Servicehinweis zu BM1 Juni 2005

Service-Hints BM1 (June 2005)

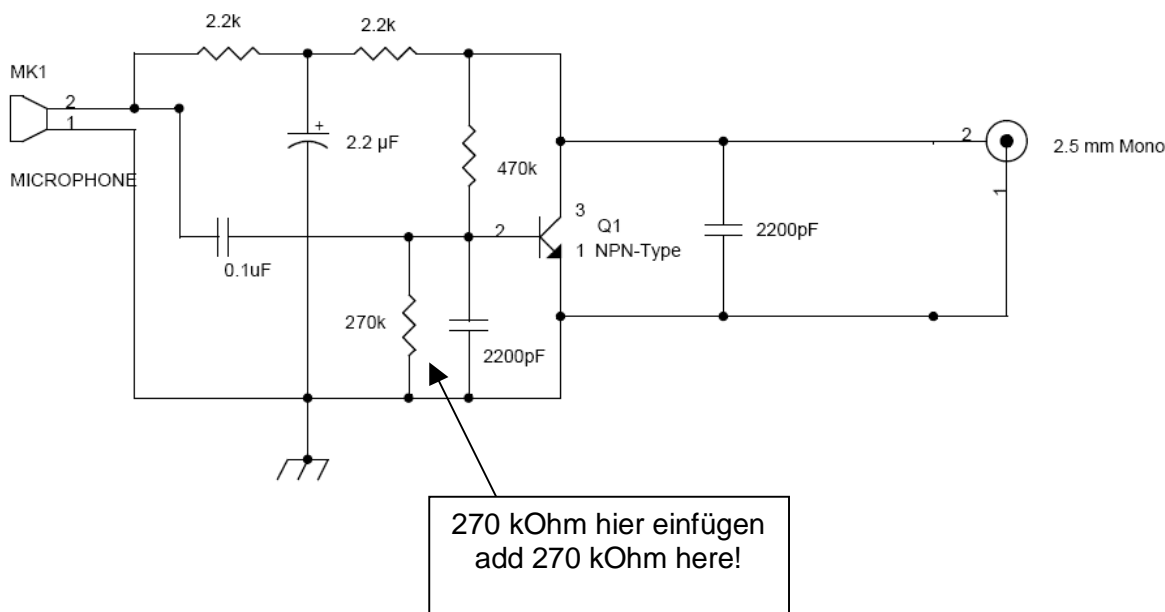
bei einigen Funkgeräten (wie ALAN 777, MIDLAND G 5, TECTALK Joker) wird im VOX Mode die PTT Tastenerkennung nicht abgeschaltet. Ein angeschlossenes BM 1 Mikrofon wird bei diesen Geräten dann fälschlicherweise als Mikrofon mit gedrückter Sprechaste erkannt. Die Folge ist, dass die VOX nicht mehr abschaltet und der Sender dauernd eingeschaltet bleibt.

Problem: Some PMR 446 radios do not disable the PTT key sensor during VOX mode. In such cases the BM 1 is detected as "microphone with permanently pressed transmit button" and as consequence the transmitter will not switch off.

Auf der Platineseite mit dem SMD Transistor 1 Widerstand 270 kOhm zusätzlich parallel zum 2200 pF Chipkondensator oder direkt parallel zu Basis und Emitter einlöten.

Add a 270 kOhm resistor parallel to the 2200 pF capacitor on the PCB side, where the transistor is soldered (or directly between base and emitter of the transistor). This bias modification will shift the resulting DC resistance into a higher range where it is no more detected as pressed PTT button.
